DESCRIPTIVE REPORT

*Field No.*     H11837     \_\_\_\_\_

*Registry No.* \_\_\_\_\_ **OPR-P385-TE-08** \_\_\_\_\_

*General Locality* \_\_\_\_\_ **Northern Cook Inlet** \_\_\_\_\_

Figure 4 – Contours from H11837 (purple) overlaid on chart 16665

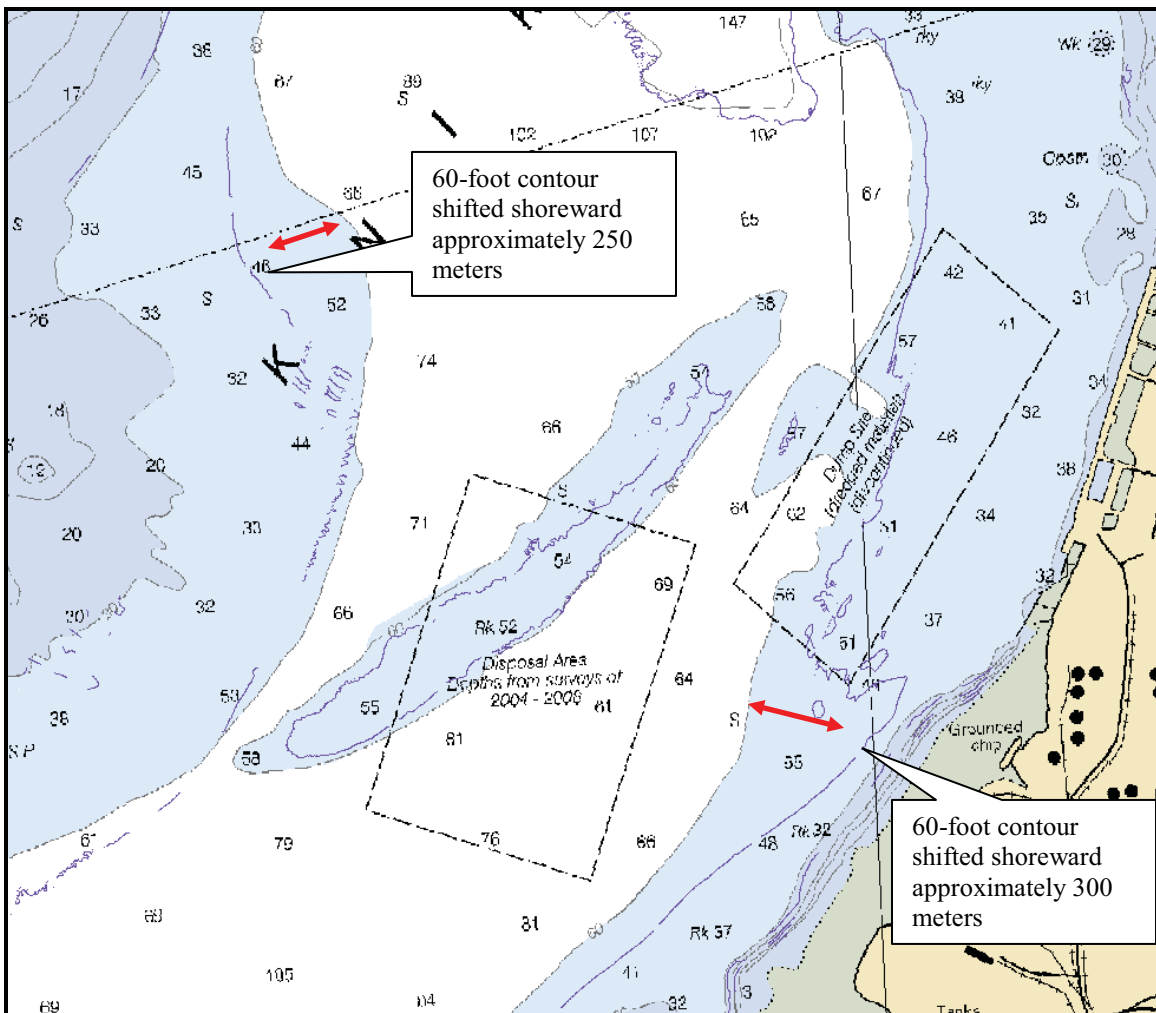
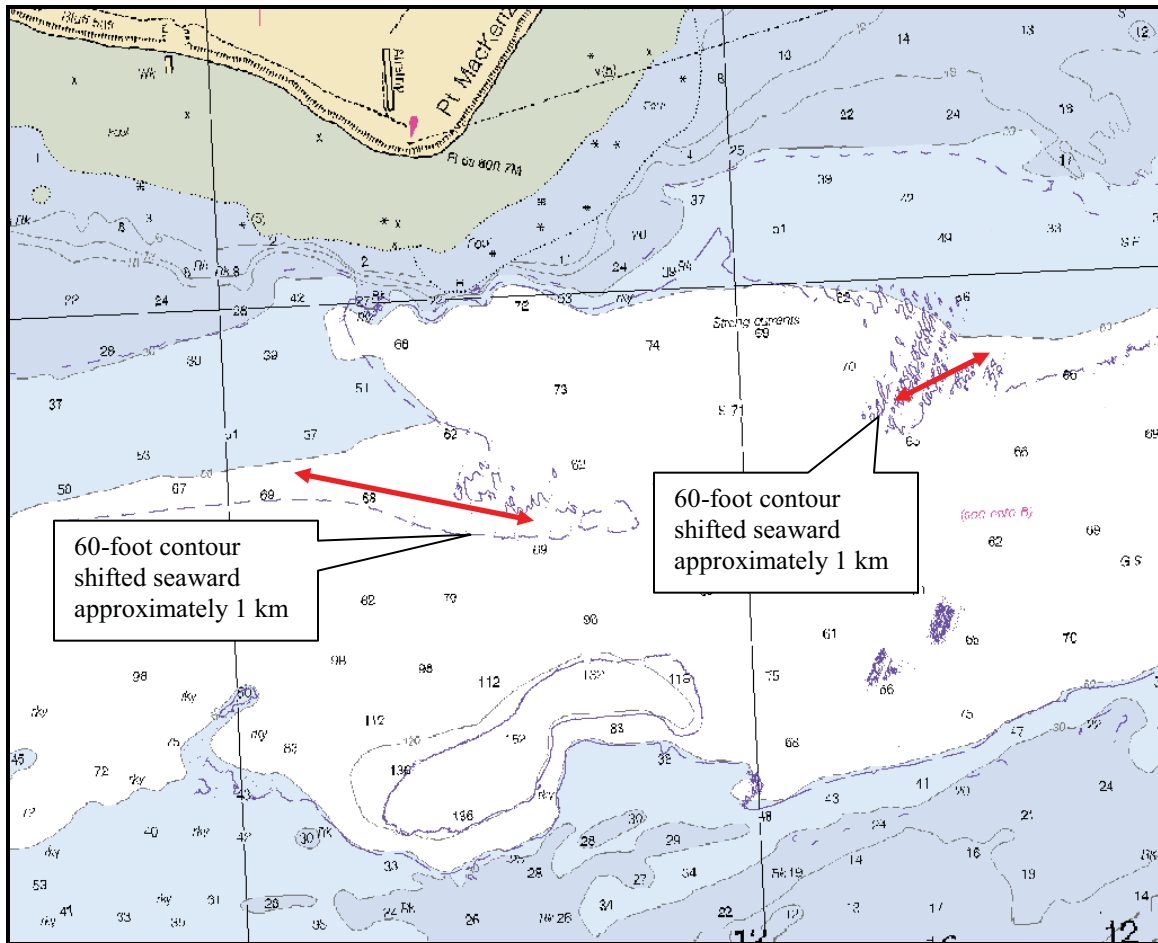
Agreement is variable across the survey area, with a few areas comparing well but most showing a shift. In the southern section of the survey area most contours have been displaced, but with no obvious trend, other than a general deepening to the east (vicinity of Anchorage) and a shoaling to the west (vicinity of Pt MacKenzie).

The hydrographer recommends that the charted contours be updated to reflect the 2008 survey data. **Concur**

Figure 1.1.1

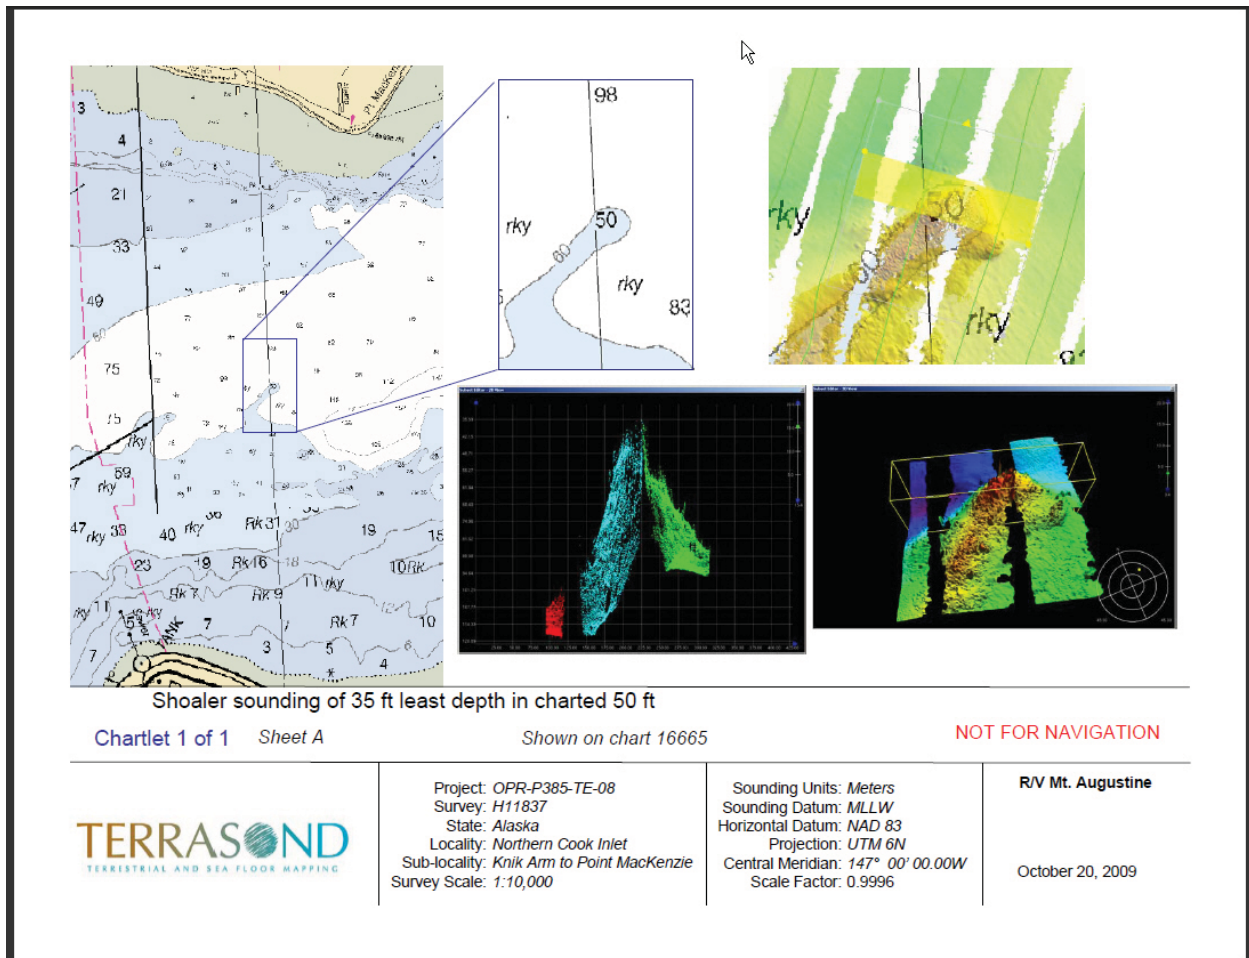
The following item was found during hydrographic survey operations. Object discovered: Rock Covered 35 feet corrected to Mean Lower Low water using GPSTide-derived correctors Shoaler sounding of 35ft least depth in charted 50ft

Recommend charting 35ft rock at surveyed location.

Concur. Chart 35ft rock at survey location.

Figure 1.2.1

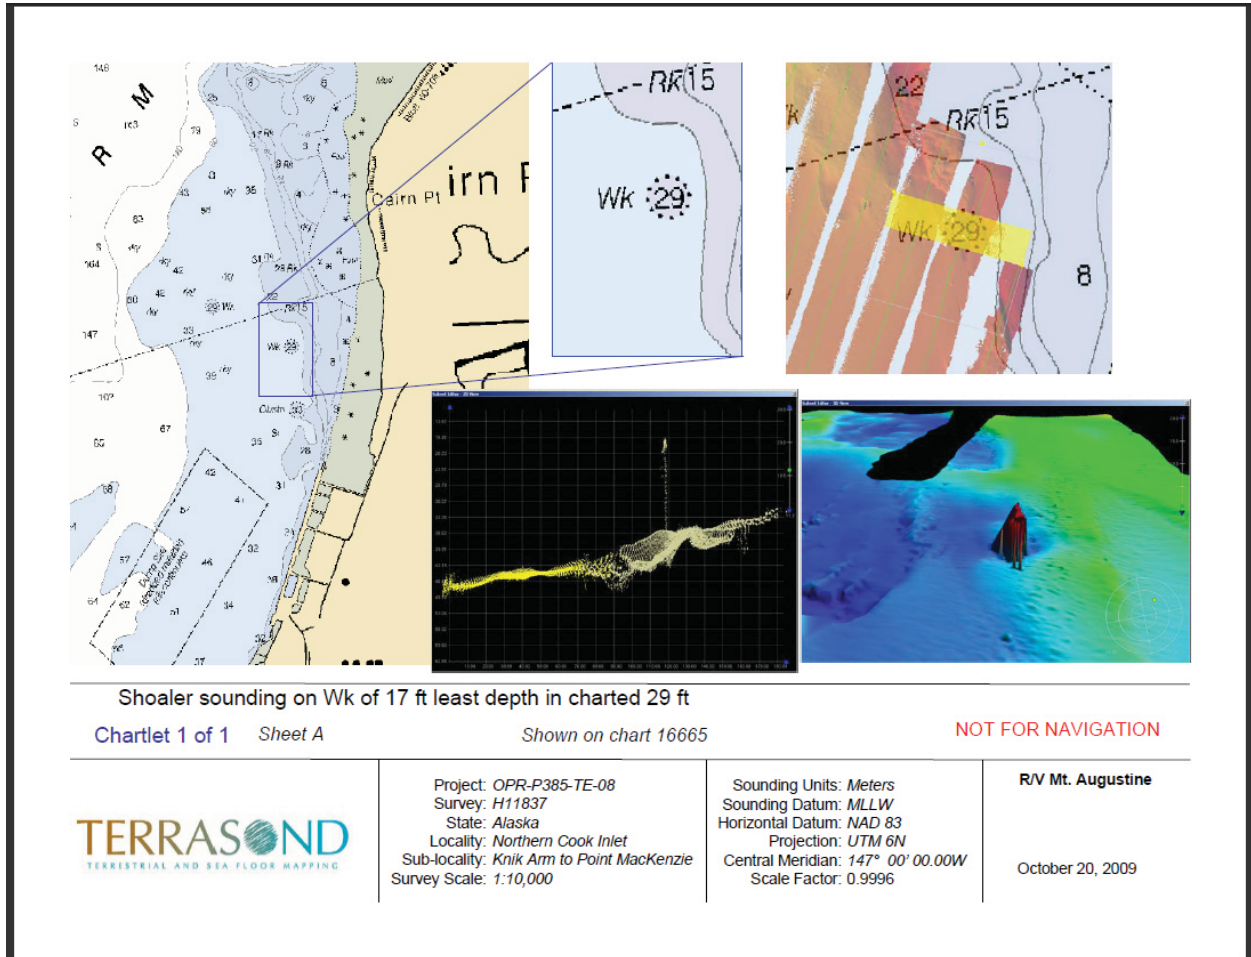
The following item was found during hydrographic survey operations. Object discovered: Wreck Covered 17 feet corrected to Mean Lower Low water using GPSTide-derived correctors Currently charted least depth on feature is 29 feet.

Recommend charting 17ft Wreck at surveyed location.

Concur. Chart 17ft wreck at survey location.
